**East Contra Costa BART Extension
(eBART) Project Final EIR**

Addendum

April 2011

RAILROAD AVENUE STATION PLAN WITHOUT WEST SIDE ACCESS
FIGURE 3

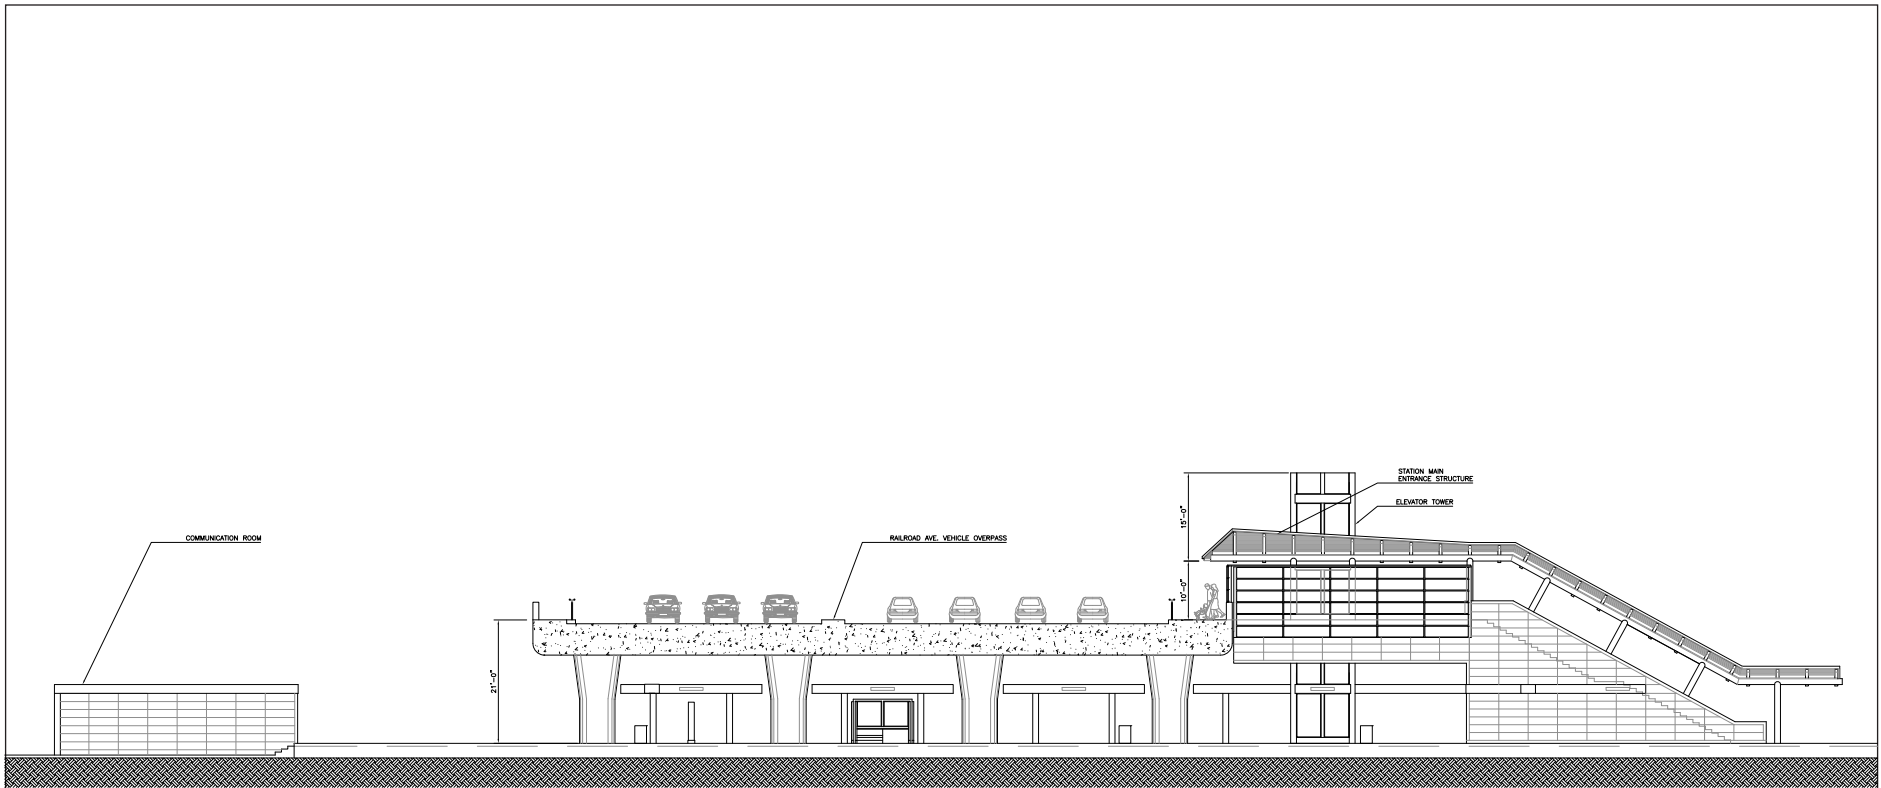
As proposed in the Final EIR, pedestrian access to the DMU station platform at the Railroad Avenue Station would be from sidewalks on the west and east side of the Railroad Avenue overpass, where one stairway and one elevator on each side of the overpass would descend to the DMU platform below. In an effort to reduce costs, an option being considered in this Addendum would eliminate the patron access from the west side of Railroad Avenue to the station platform. Figure 3 shows the Railroad Avenue Station without west side access. Patron access from the east side of Railroad Avenue to the station platform (one stairway and one elevator) would remain unchanged, but this option would eliminate all access from the west side of Railroad Avenue.

HILLCREST AVENUE STATION REVISED PROJECT SITE PLAN
FIGURE 4

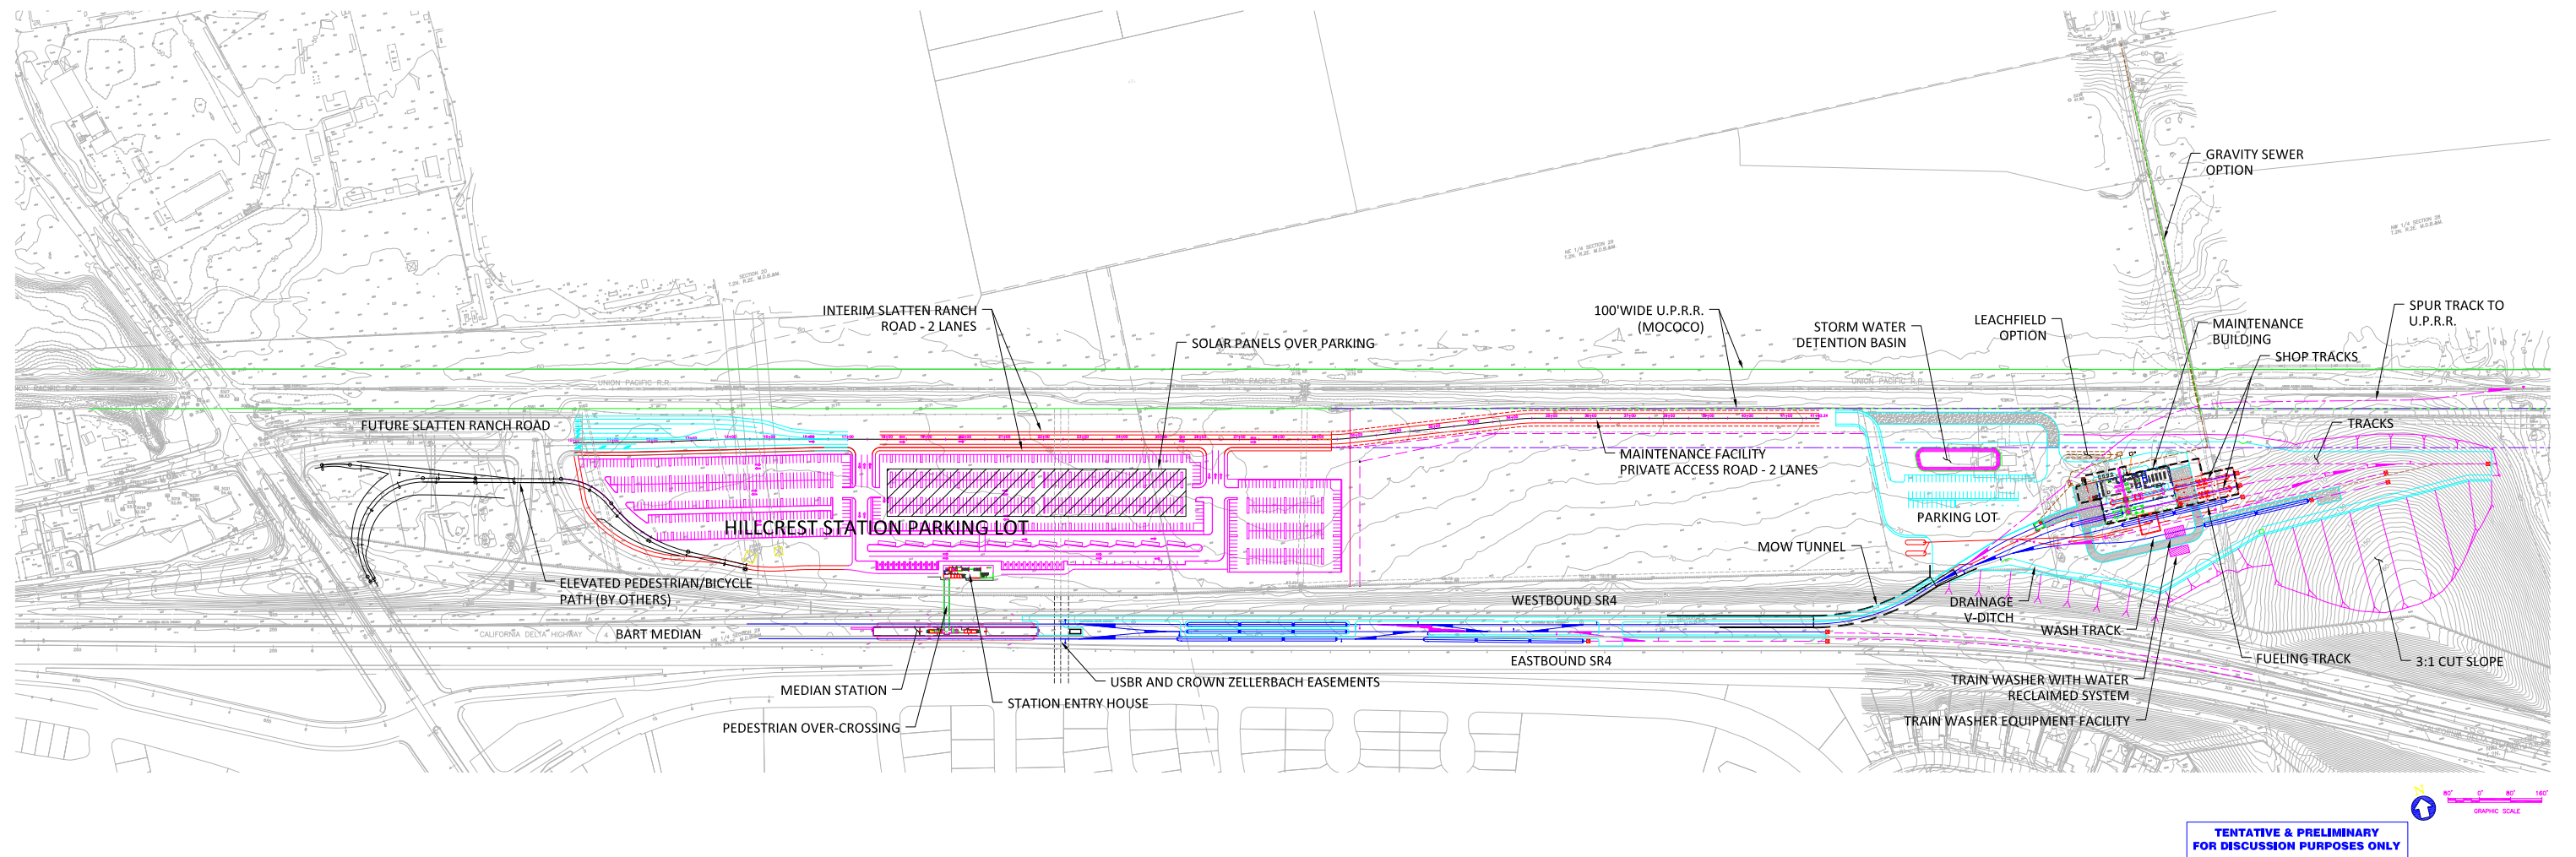
A number of changes to the adopted Hillcrest Median Station site plan are being considered: (i) relocation of the parking lot to the east; (ii) elevation of the relocated parking lot above the surrounding grade to allow a future connection to Viera Avenue (extending from the north) to cross over the Union Pacific Railroad (UPRR) tracks; (iii) expansion of the DMU Control and Maintenance Center; (iv) realignment of the proposed access road serving the parking lot and the maintenance center; (v) installation of solar panels over the center of the parking lot; (vi) excavation of the knoll at the east end of the project site to accommodate the expanded Control and Maintenance Center and to provide fill for the elevated parking lot; and (vii) relocation of certain utilities. Figure 4 illustrates the proposed design.

The Revised Project would relocate the Median Station parking lot from its original location adjacent to Hillcrest Avenue north of SR 4 to a location approximately 800 feet east of Hillcrest Avenue. The location of the eBART station platform would remain unchanged. As described in the Final EIR (pages 2-19 – 2-19a), the Hillcrest Station parking lot will be constructed in two phases. Phase 1, for

REVISED PROJECT FOOTPRINT COMPARED TO ADOPTED PROJECT FOOTPRINT
FIGURE 9

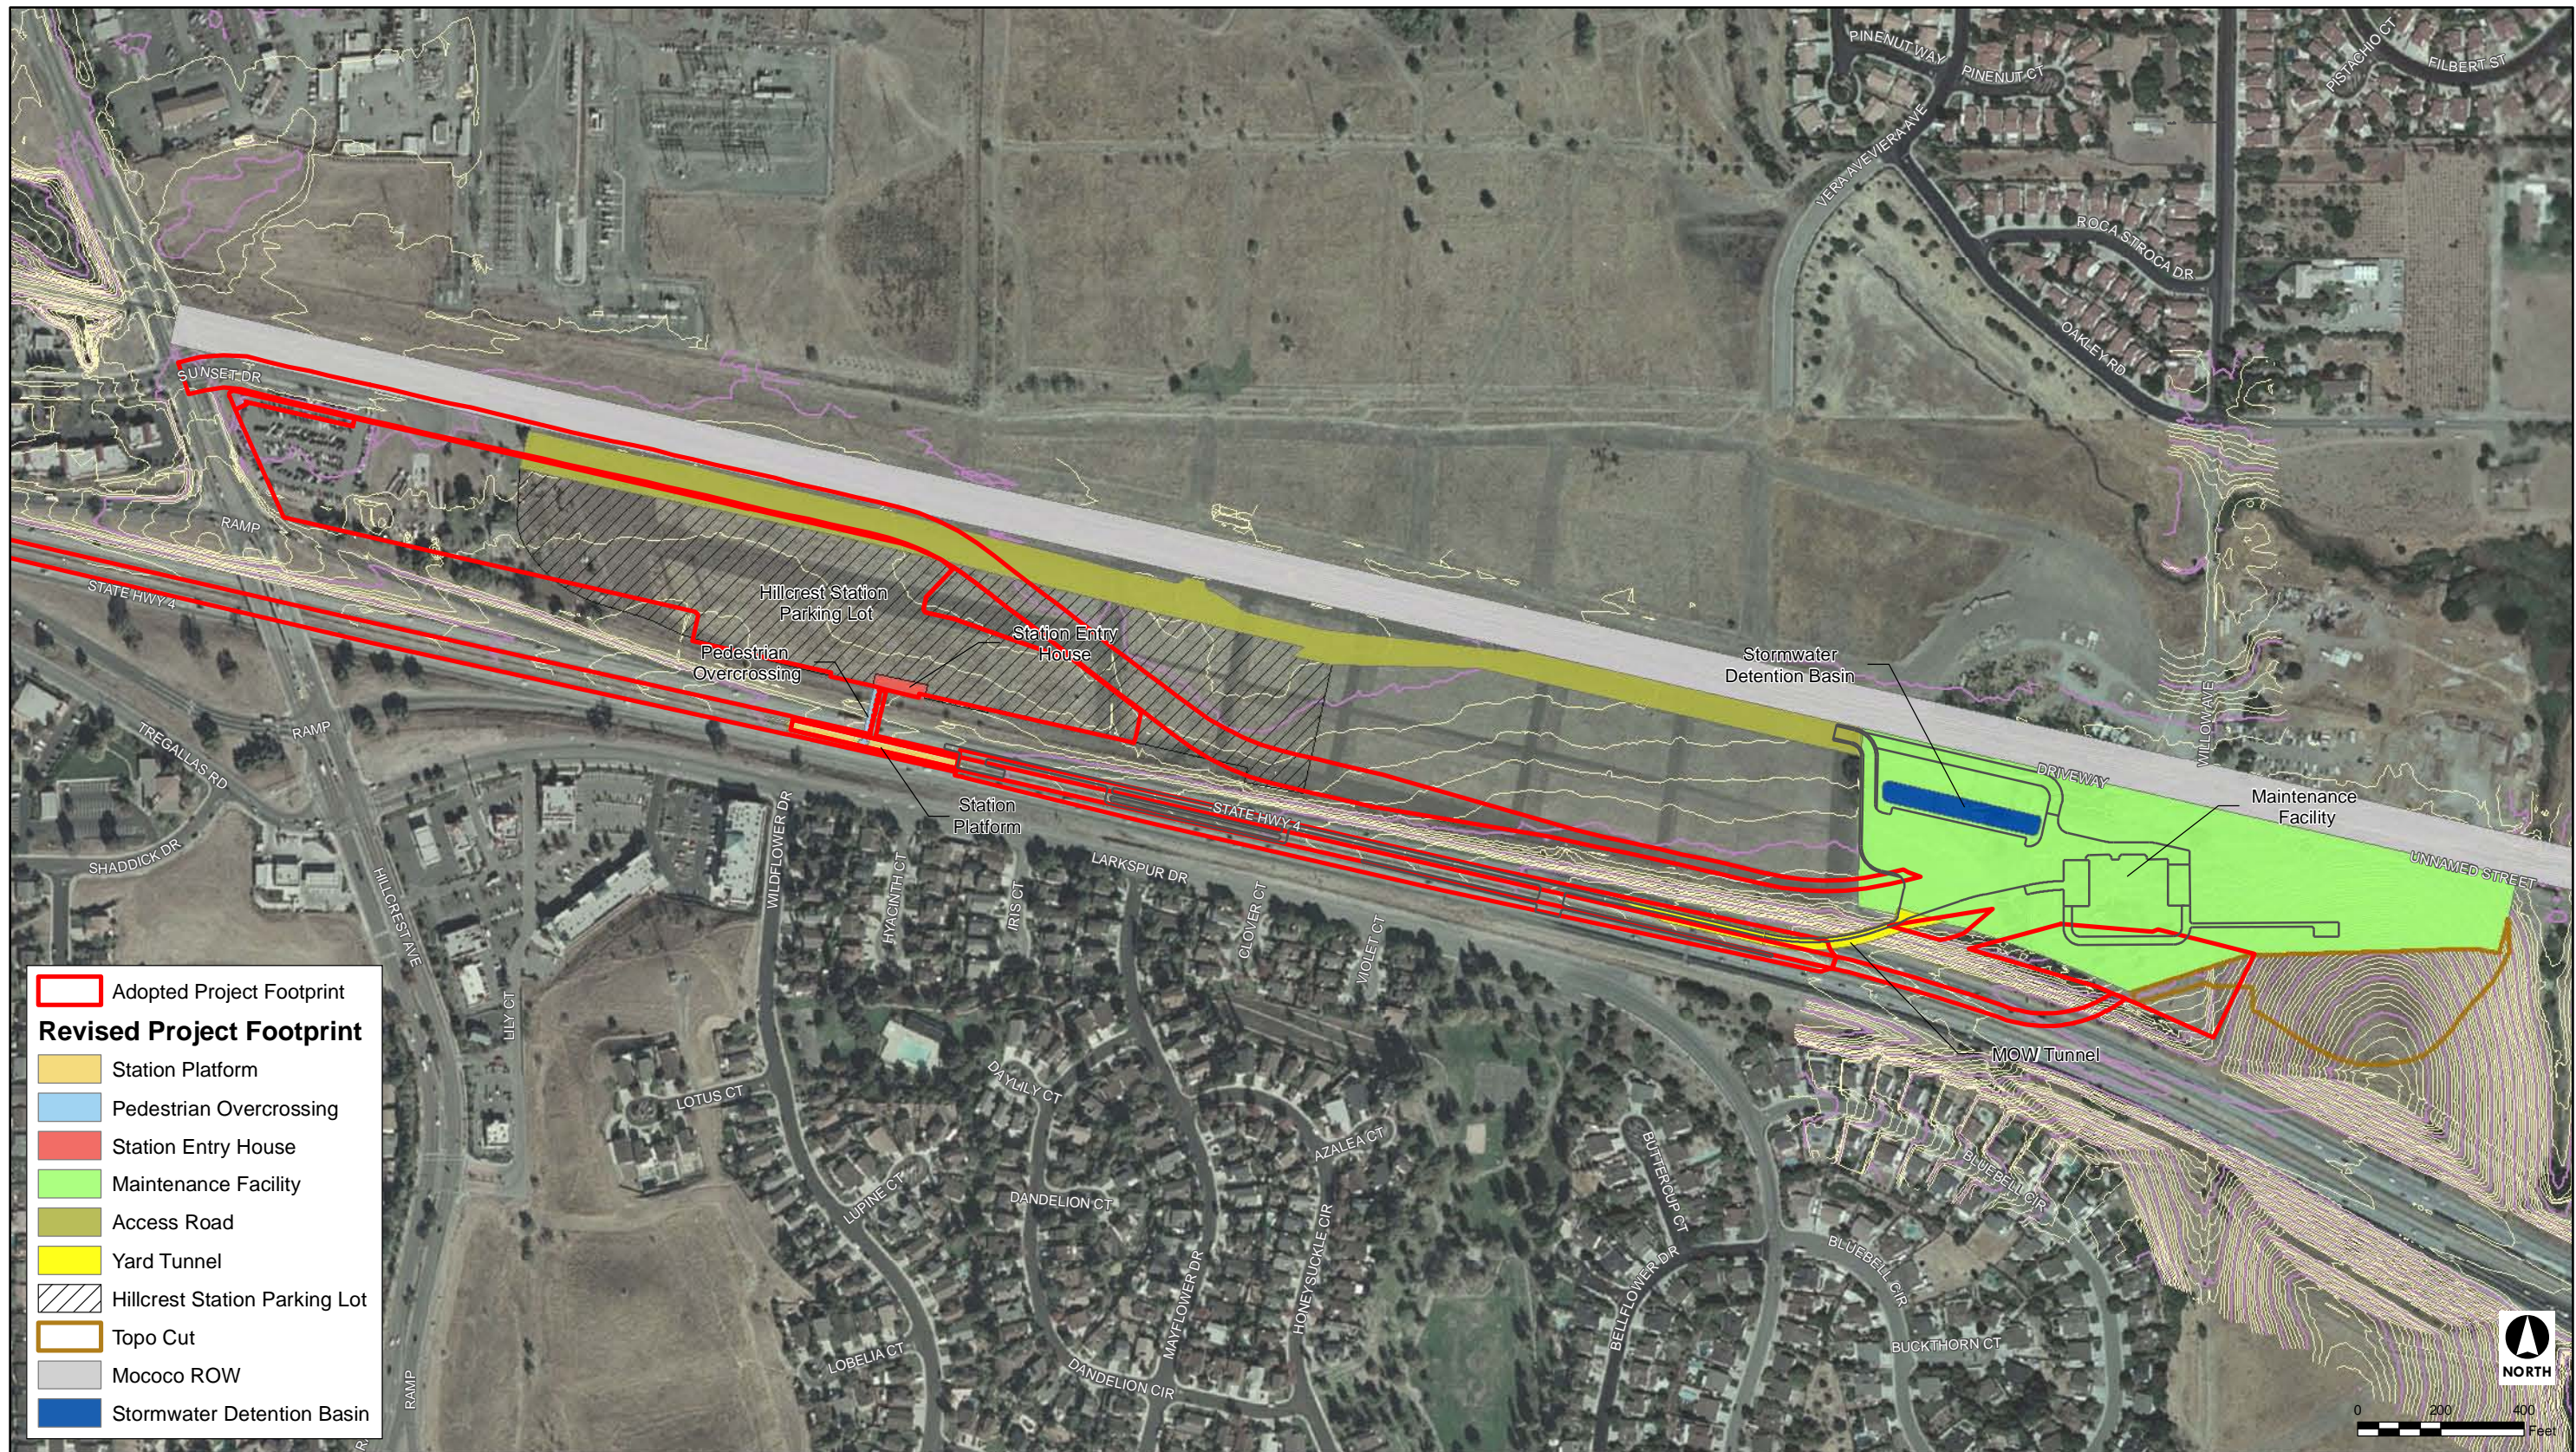
As noted in the Project Description, a number of changes to the adopted Hillcrest Median Station site plan are being considered: A number of changes to the adopted Hillcrest Median Station site plan are being considered: (i) relocation of the parking lot to the east; (ii) elevation of the relocated parking lot above the surrounding grade to allow a future connection to Viera Avenue (extending from the north) to cross over the Union Pacific Railroad (UPRR) tracks; (iii) expansion of the DMU Control and Maintenance Center; (iv) realignment of the proposed access road serving the parking lot and the maintenance center; (v) installation of solar panels over the center of the parking lot; (vi) excavation of the knoll at the east end of the project site to accommodate the expanded Control and Maintenance Center and to provide fill for the elevated parking lot; and (vii) relocation of certain utilities. In order to provide a comparison between the adopted Hillcrest Avenue Median Station site plan and the Revised Project, Figure 9 shows an overlay of the Revised Project footprint compared to the footprint of the site plan adopted by the BART Board in April 2009. The following analysis addresses the potential for impacts associated with the changes proposed under the Revised Project compared to the Adopted Project.
